VULCAN PHASE 3.3

535 8th Ave North  
Seattle, WA 98109

### **PROJECT #: #3039270-LU**

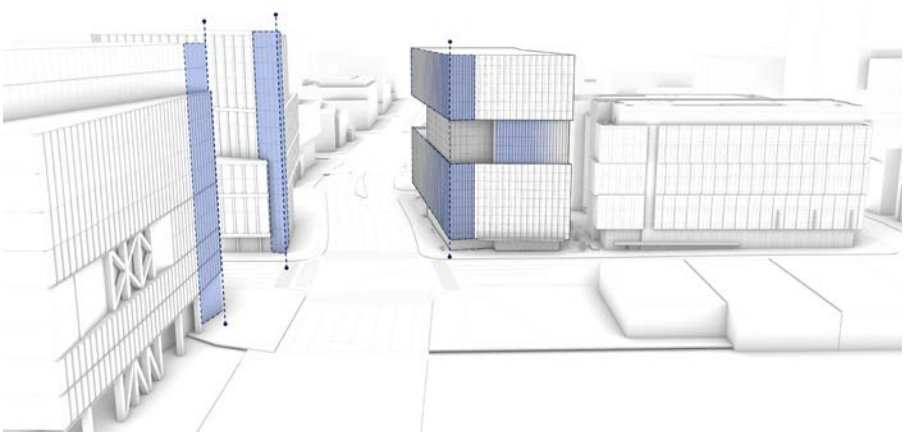
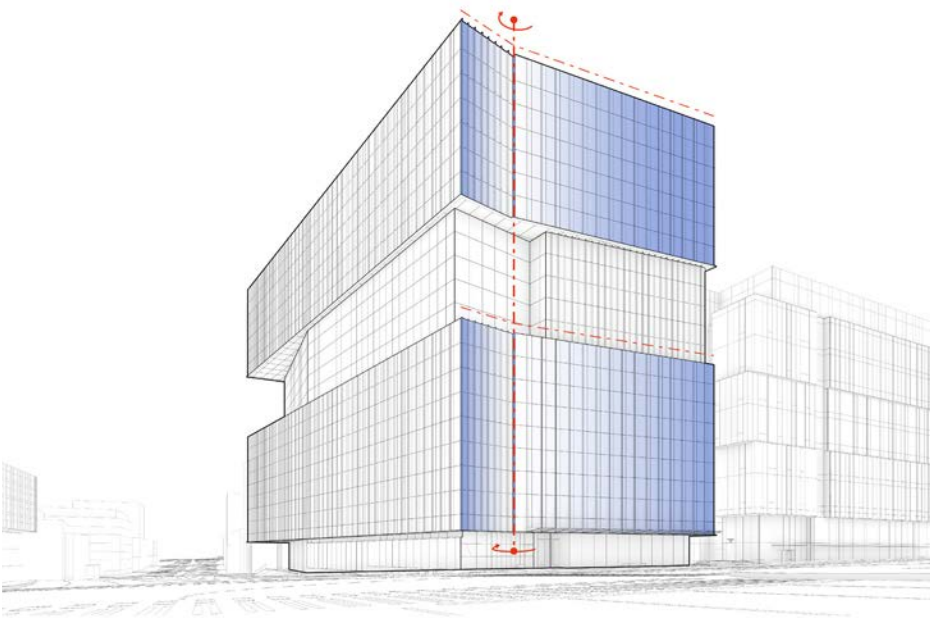
The Board reiterated their support of the overall architectural massing concept and the large scaled dynamic gateway gesture at the east end of the building proposed at Early Design Guidance. However, in agreement with public comment, the Board was concerned that the slight shift in angle of the massing proposed along Dexter Ave N did not go far enough to reinforce the gateway architectural concept when viewed from the west. The Board was also concerned that when compared to previously approved projects on the other corners of Dexter Ave N and Dexter St, the proposed massing lacked the same strong statement made by those buildings through major massing modulation or larger compositional elements. The Board directed further study of the mass at the west end of the building to include more visually evident interventions that better relate to the projects across the street that mark the same gateway location. CS2-1, CS2-3, CS2-4, DC1-1, DC2-A, DC2-

The design of the massing along Dexter has been revised to introduce bold gateway moves that emphasize the west face and northwest corner while establishing strong relationships to context. The west faces of each of the four primary volumes have been fractured, inflected, and offset to create a strong vertical reading oriented towards the northwest corner. The revised massing moves relate directly to neighboring context and are enhanced and complimented by additional secondary and tertiary treatments of materials, textures, colors, and composition.

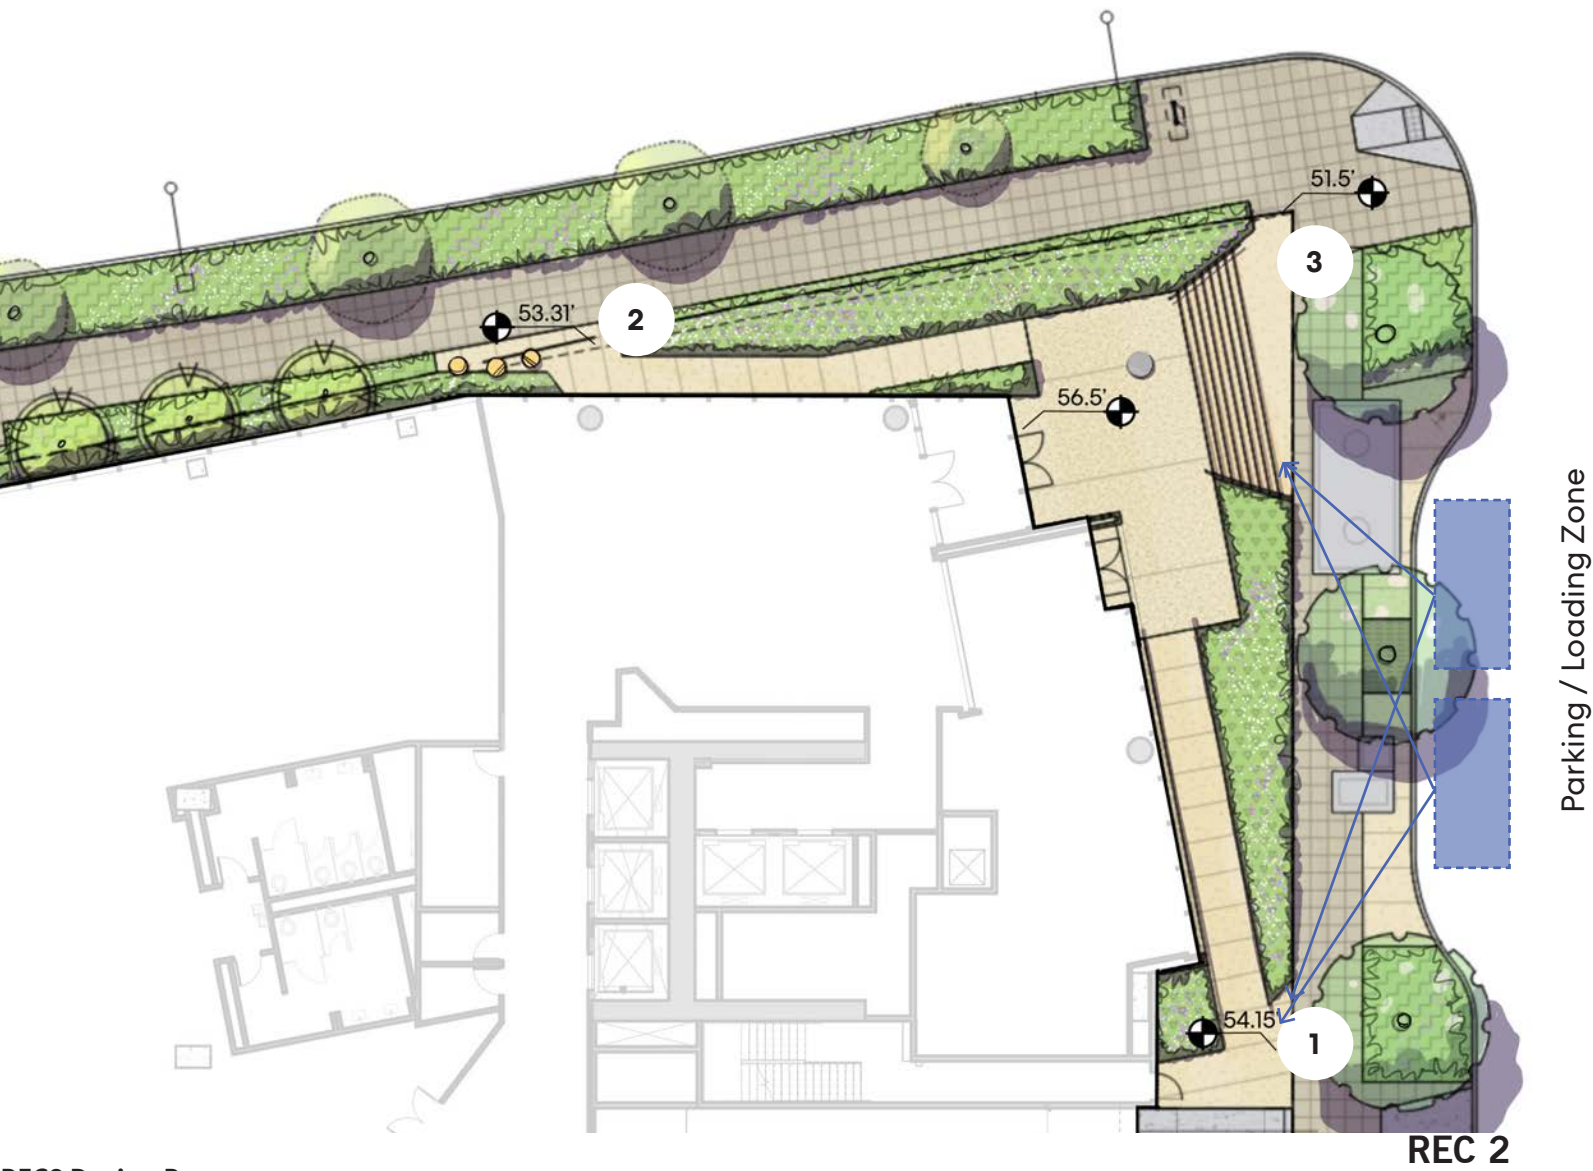
The Board acknowledged that the topographic change along the Mercer St and 8th Ave N sidewalk edges and interior programing are design constraints affecting access to the lobby and retail spaces; however, they were concerned that the integration of the accessible ramp and the overall interaction with the right-of-way had not been adequately studied per guidance given at EDG. The Board directed further study of the overall design of the entry sequence to incorporate more generously sized accessible ramps that provide more equitable access between the public right of way and building entries, including landings located closer to the main entry stair and the intersection. CS1-C-2, CS1-3-a, PL2-A

The design along 8th has been revised to better integrate accessible approaches. Several alternative strategies have been explored, and are illustrated on the following pages. The preferred/proposed option (shown above) on 8th includes the following enhancements and revisions:

1. Widened approach and pathway on 8th, to be more prominent as well as gracious. This maintains equitable approach from the south along 8th and the balanced approach to access from the parking/loading zone, where the southern vehicle is closer to the ramp than the stairs and the northern vehicle is closer to the stairs than the ramp.
2. Simplified and widened approach and pathway on Mercer. The widening of the approach coupled with wayfinding signage visible from the intersection of 8th and Mercer better identify the building entry and retail.
3. Expanded main entry stair, engaging the corner. This adjustment brings the stair up to the scale of the architectural moves it sits within, while also providing clearer access from the corner of 8th and Mercer.

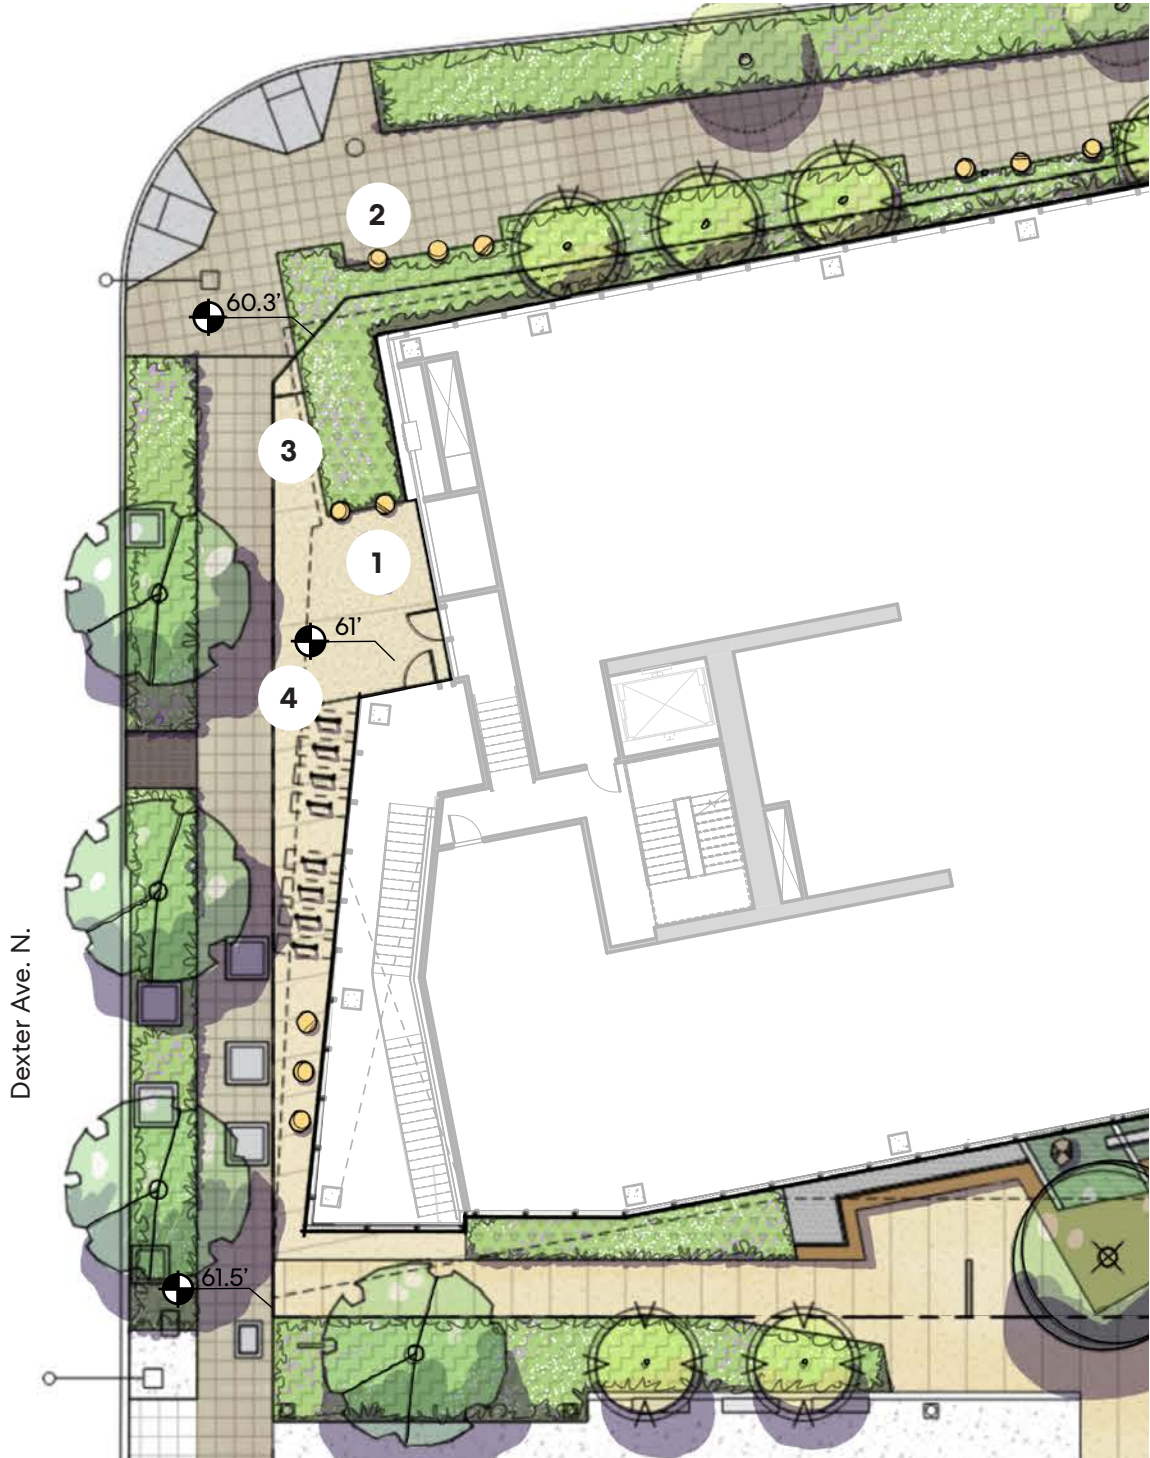
The Board discussed whether the lone bench element proposed at the corner of Dexter Ave N and Mercer St successfully created a sense of place at the prominent gateway corner, as described by the applicant in the Recommendation presentation. The Board ultimately directed the applicant to further study the overall design of this prominent corner to ensure that right-of-way and landscape elements appear integrated with the architecture and enhance the overall pedestrian realm. CS2-B, CS2-4-c, PL1-1, DC3-B, DC3-C, DC4-2

The design at NW corner has been revised to improve the pedestrian experience and better respond to the gateway corner with a placemaking strategy.

- 1. Additional setback and covered open space have been added to expand cyclist mount/dismount zone of arrival and departure.
- 2. Enhanced planting and site furnishings have been provided - continues along Mercer.
- 3. Space is activated with cyclist entry facing corner while preserving access to bike amenities farther south along Dexter and opening access to the mid-block.
- 4. Expression and identity of the cyclist entry and space is enhanced by plan/form revisions.

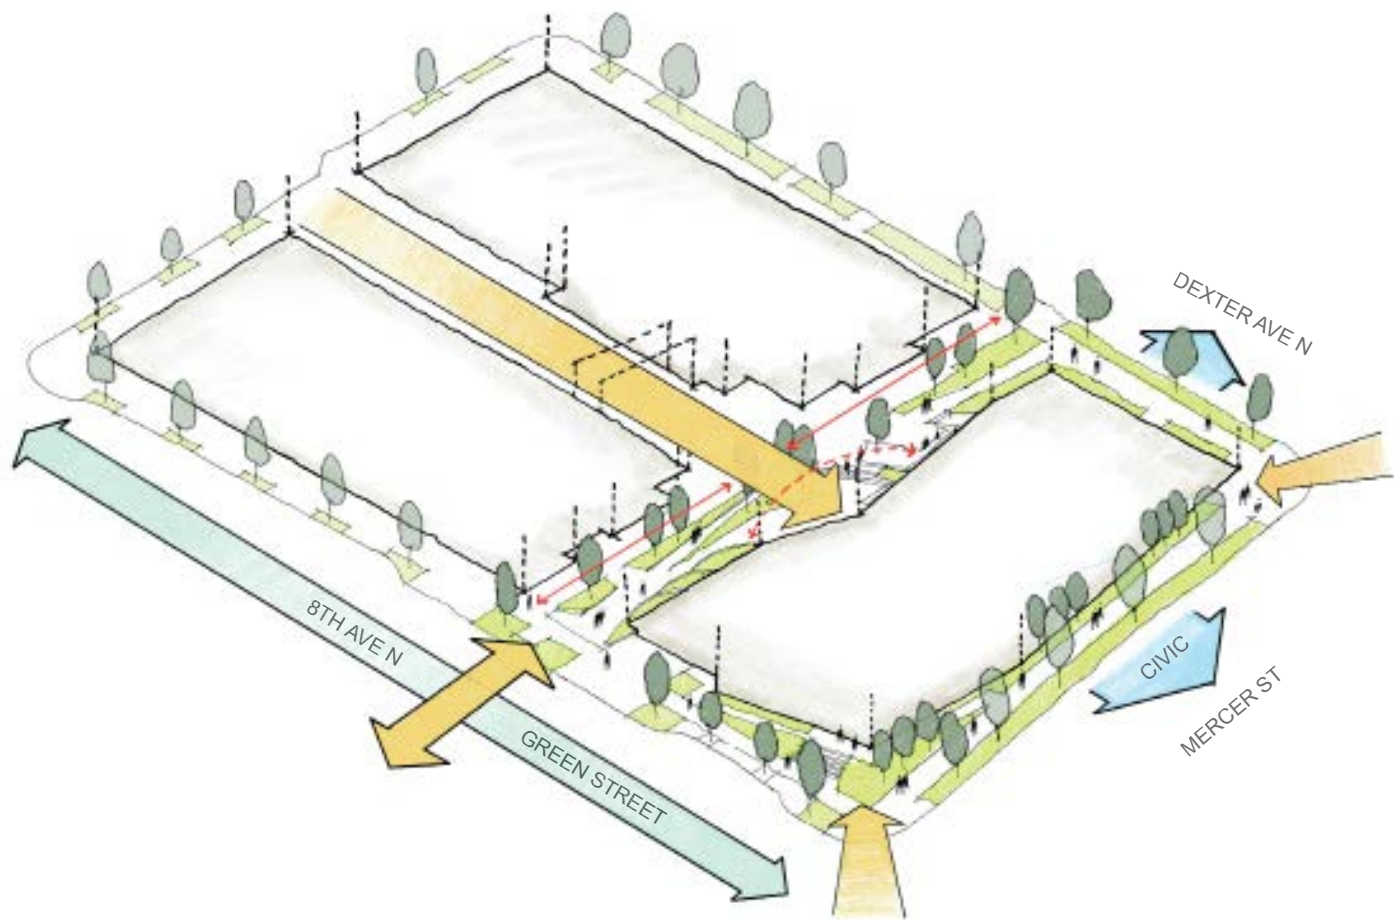
The Board supported the overall intentionally composed landscape and lighting design of the plaza at the north end of the courtyard between the two UW Medicine buildings that enhanced the pedestrian experience and successfully contributed to the network of mid-block connectors in the neighborhood. The Board specifically noted that the landscape under the large building overhangs would not receive adequate water to survive unless proper irrigation was provided. The Board directed the applicant to include irrigation information in the next Recommendation packet. CS2-B, CS2-4-c, PL1-1, DC3-B, DC3-C, DC4-2

The design intent is to provide separate irrigation zones for those areas that are under cover to allow them to get the year-round water they need to thrive in these conditions. Similar strategies have been employed and successfully maintained by this development team across the South Lake Union neighborhood. Refer to irrigation plan on following page.

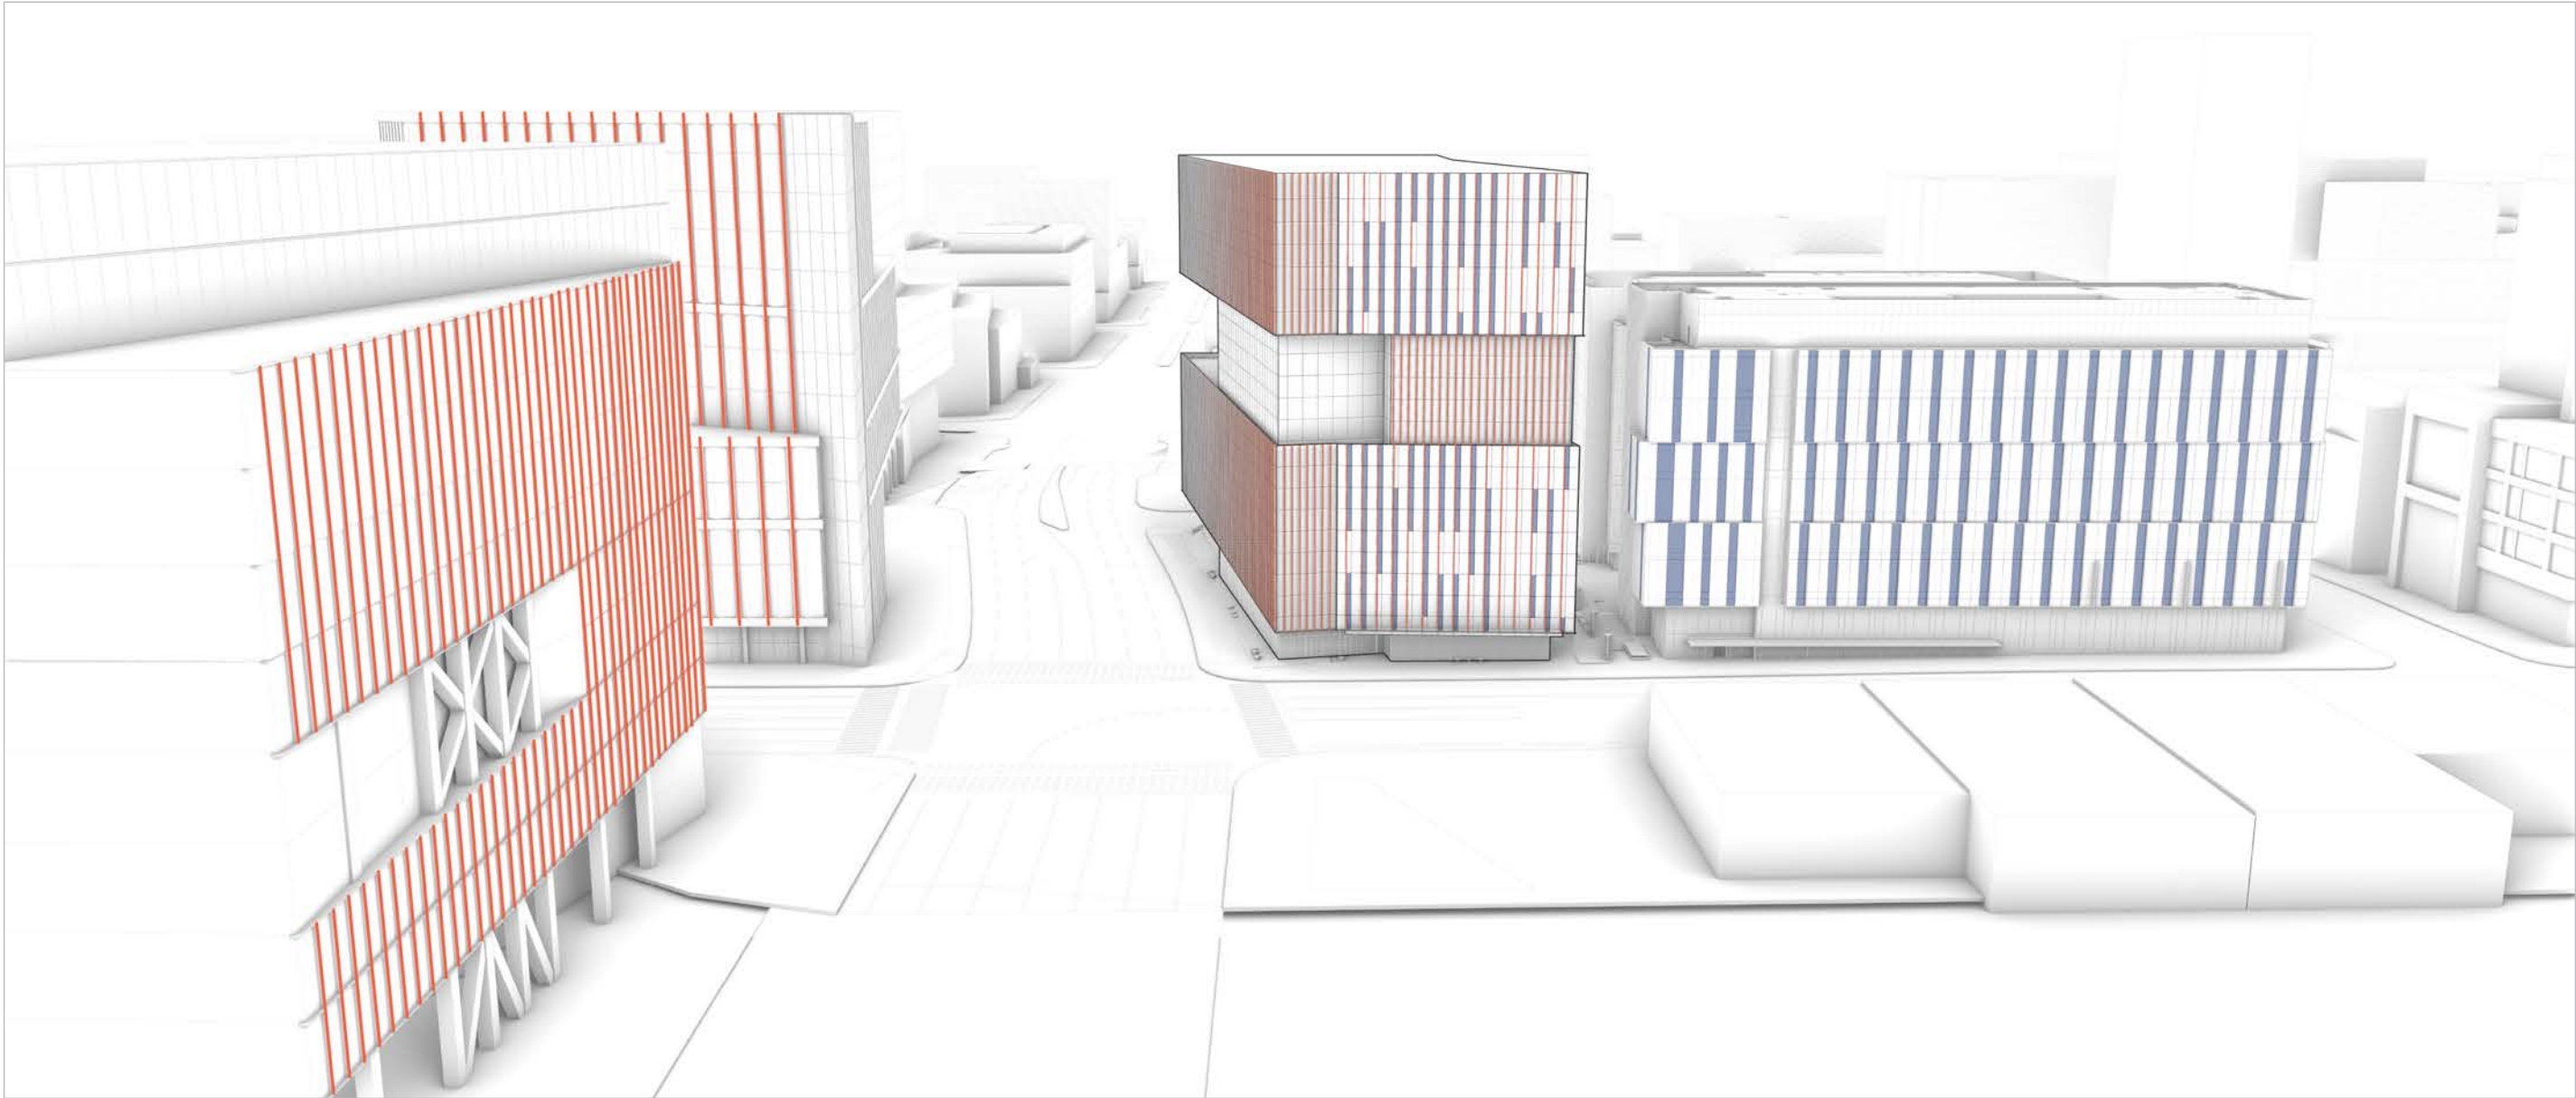
In agreement with public comment, the Board was concerned with the lack of façade articulation, secondary architectural features, and noticeable differentiation in material application to enhance the legibility of the overall ‘Slipped Hinge’ architectural concept supported at EDG. The Board noted that although the clean glass stacked boxes expressed a clear architectural concept and form, when compared to the level of visual interest applied to the adjacent buildings and the projects across the street, the proposed design appeared to exacerbate the perceived height, bulk, and scale of the proposal, rather than complement the existing neighborhood context. Moving forward, the Board directed the applicant to explore ways to provide a secondary level of visual interest and depth in the facades through the weaving of changes in window types, varying mullion spacing, frit patterning, color accents, material inserts, projections, or other elements to reinforce the overall architectural concept and response to context. CS2-1-c, DC2-A-2, DC2-B-1, DC2-C-1, DC2-D, DC2-I, DC2-5, DC2-6, DC4-

The design has been substantially revised to incorporate further facade articulation, secondary architectural features, texture, depth, and variations in the materials and details to enhance the legibility of the "Slipped Hinge" concept. The elements incorporated include varying mullion spacing, frit patterning, materials, and projections.

As detailed and described on the following pages, a comprehensive re-design strategy for the exterior expression of the building is proposed to respond to REC1 guidance. The design response employs the following massing articulation, secondary architectural features, and material application revisions from REC1; composed according to a design logic grounded in the context, guidelines, and guidance.
